# Appendix E – Hydrology and Water Quality Supporting Information

**Subject: Peer Review of Select Hydrology and Water Quality Technical Analyses from the Z-Best Project Applicant**

**RE: RESPONSE TO “MEMORANDUM: FURTHER CLARIFICATION OF HYDROLOGY AND SUPPLY ANALYSES AND THE GROUNDWATER DRAWDOWN EVALUATION”**

**Revised Drawing 13**

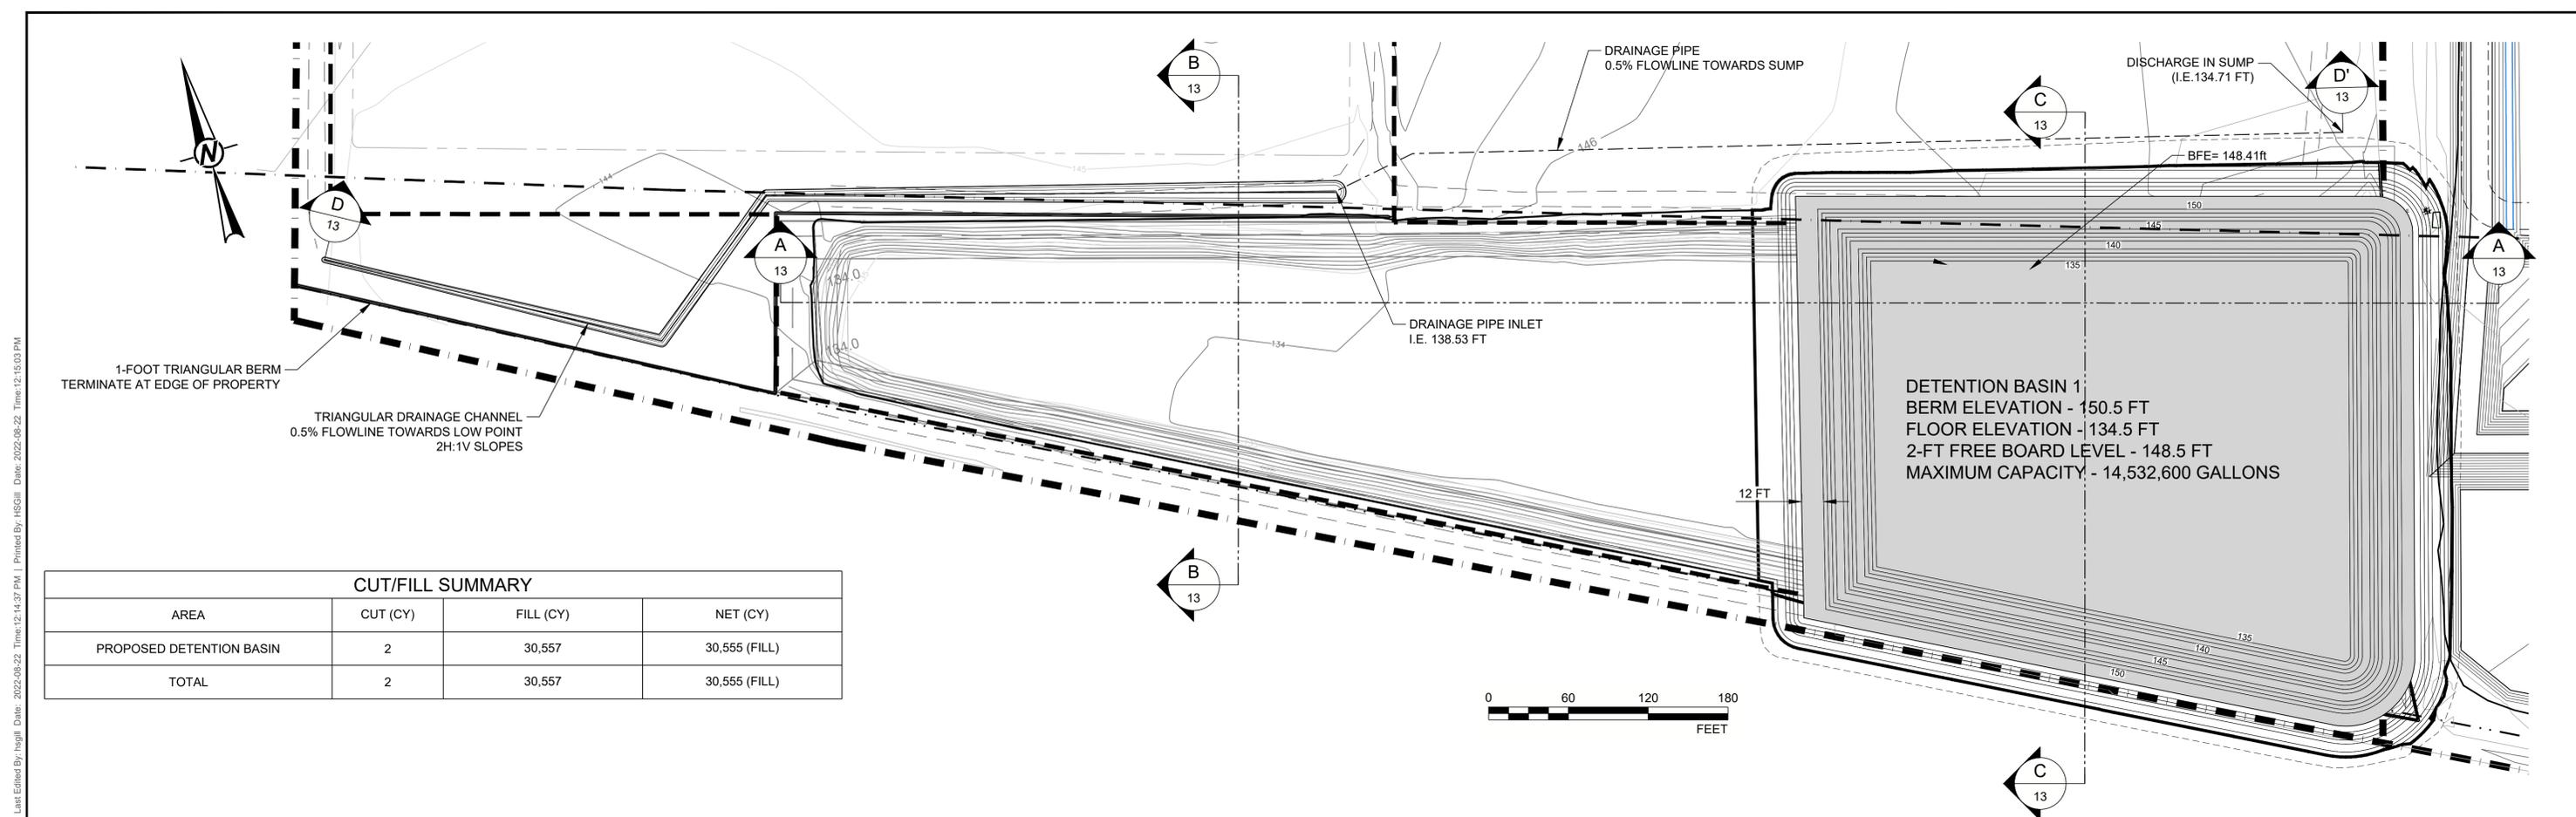
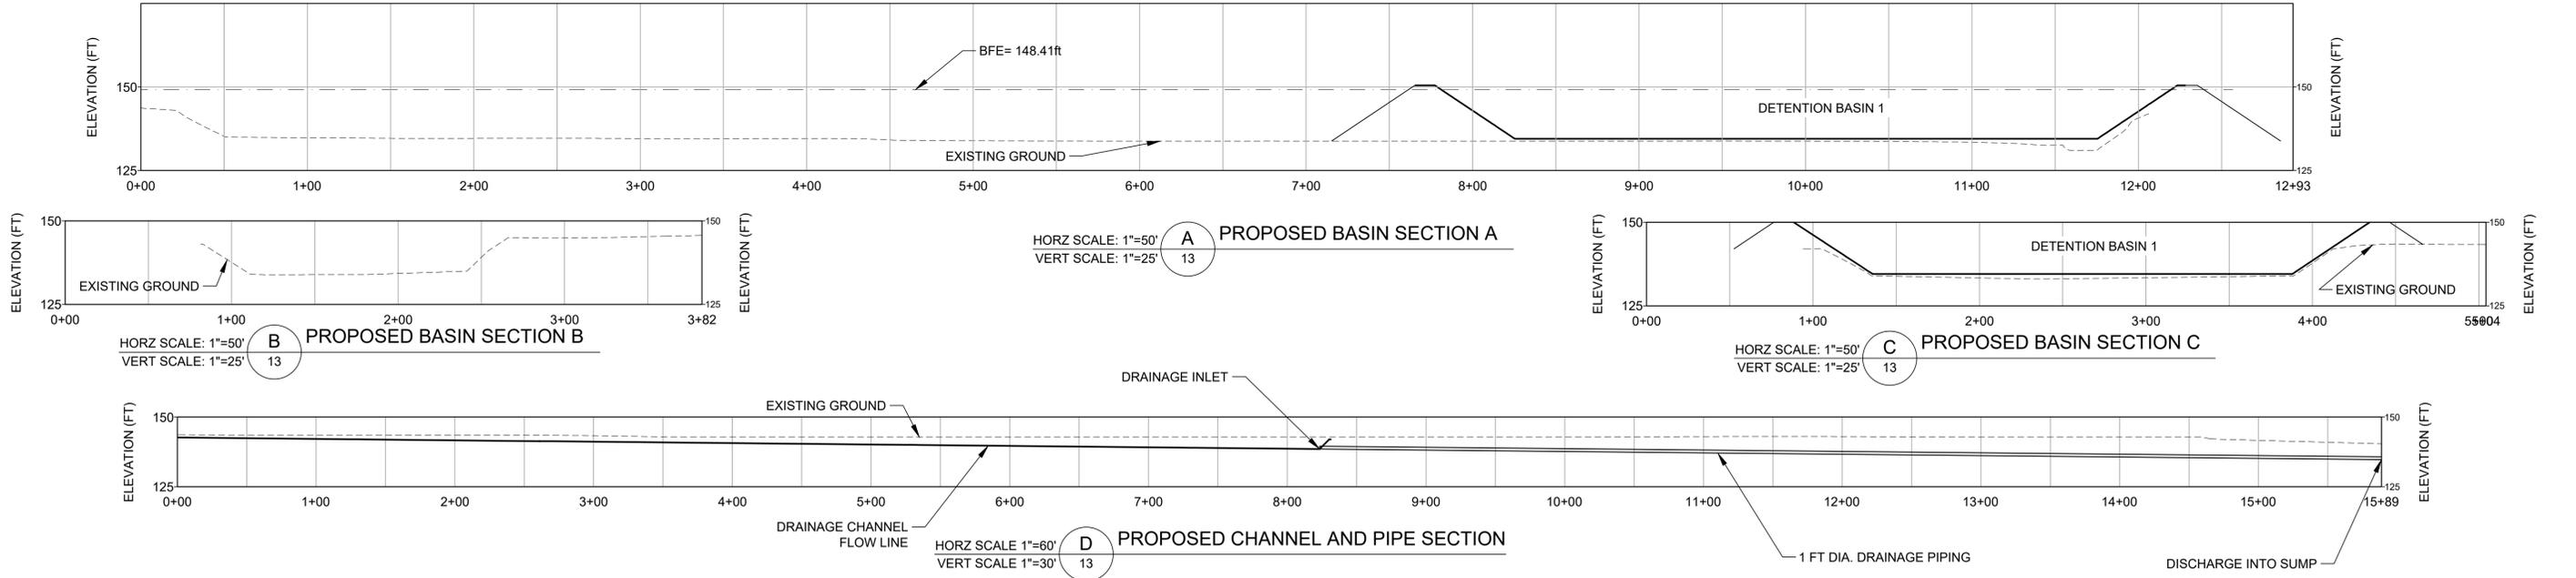
- 5. The Golder memo mentions a drainage ditch to be constructed along the north side of the western portion of Detention Basin #1, which does not appear to be shown on the project plans. Please provide an updated Drawing 13 showing the location and contours of the proposed drainage ditch and provide north-south sections through the western and eastern portions of the detention basin showing both existing and proposed ground surfaces. Please also update Proposed Basin Section A on Drawing 13 to show the proposed ground surface on the outer slopes of the Detention Basin #1 berms, which are currently missing from the section.*

A revised drawing 13 is attached.
